MEMORANDUM

Re: Changes to the Centro Civico Senior Housing Project at 145 S 600 W
Planned Development and Conditional Building and Site Design Review
PLNSUB2017-00370 & PLNPCM2017-00525

Re: PLNSUB2017-00370 & PLNPCM2017-00525 – Centro Civico Senior Housing – Planned Development & Conditional Building and Site Design Review

Revised west elevation showing additional dimensions.

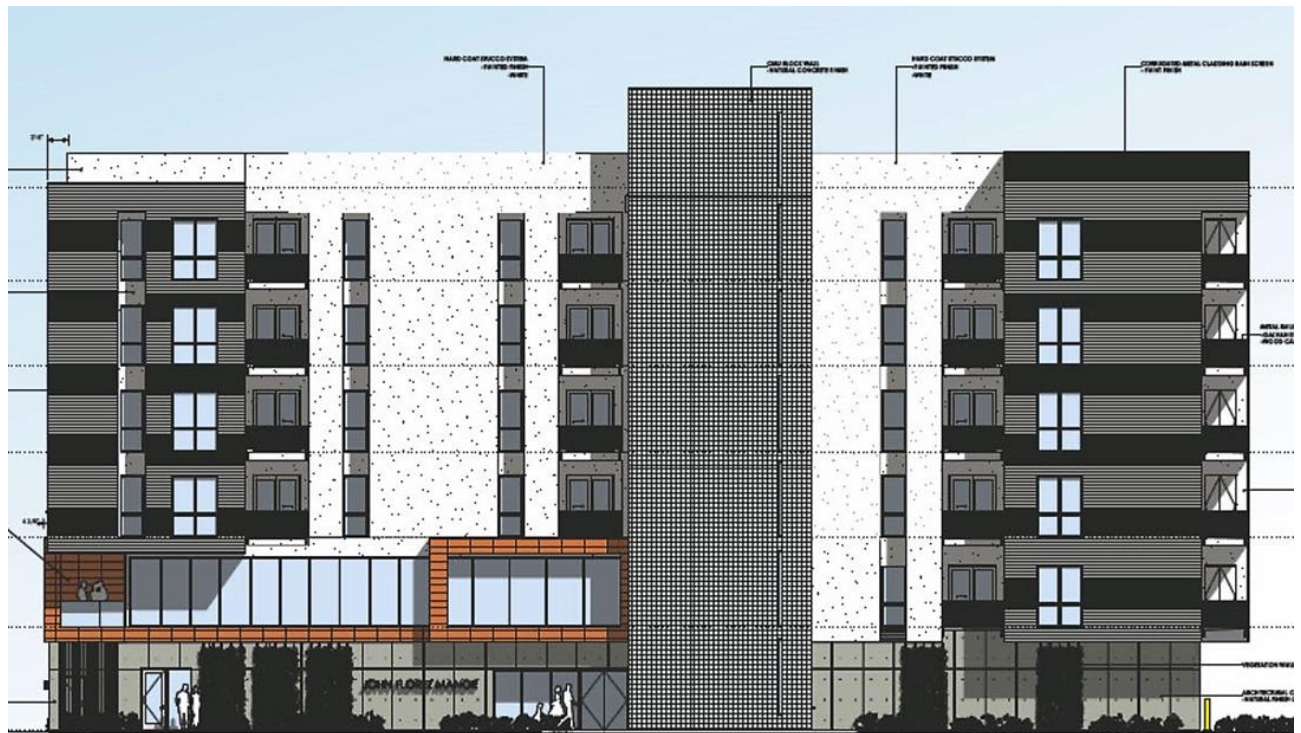
Follow-up Note: The applicant has provided a revised drawing of the west elevation that incorporates additional dimensions. This drawing shows the total length of the west façade as 67 feet. The length of blank wall that is discussed in Issue 2 is show as 25-feet in length. The revised elevation is included in this report in [Attachment C](#).

- **West Building Façade/Windows/Street Presence** – There was discussion and concern expressed about the lack of contrast/changes on the upper 4 floors of the west elevation. The main concern with the proposed metal surface is the monotony that it would impart. The possibility of the west elevation presenting a “shiny blank wall” with the lack of windows and metal siding was a concern. Suggestions included an exploration of varying metal colors, a mural or some other community or project art being incorporated into that elevation to break up the stark character.

The main concern with the proposal concerns the design of the west-facing front façade on 600 W and more specifically the lack of windows and contrast included on that elevation of the building. While the main lobby entrance to the building is located on the south side of the building, the west elevation is the public street facing portion of the building that will be most visible on 600 West. On the 600 West elevation, there are very few windows on the upper floors. The applicant has indicated that this is a result of balancing the solar heat gain of the western windows with the impact on utility costs for low-income seniors. Glass has been incorporated at ground level. The Gateway District Urban Design standards largely address pedestrian interaction at the ground level of buildings. The proposal does appear to meet the 40% front minimum first floor glass for the street facing elevation of the building per 21A.31.010.P.3. The proposal shows the glass area as 41% which would meet the requirements.

Follow-up Note: Revised plans to address this issue have not been submitted by the applicant as of the date of this report. The applicant has indicated that they will address this item in person with the Planning Commission when the application is before them for decision.
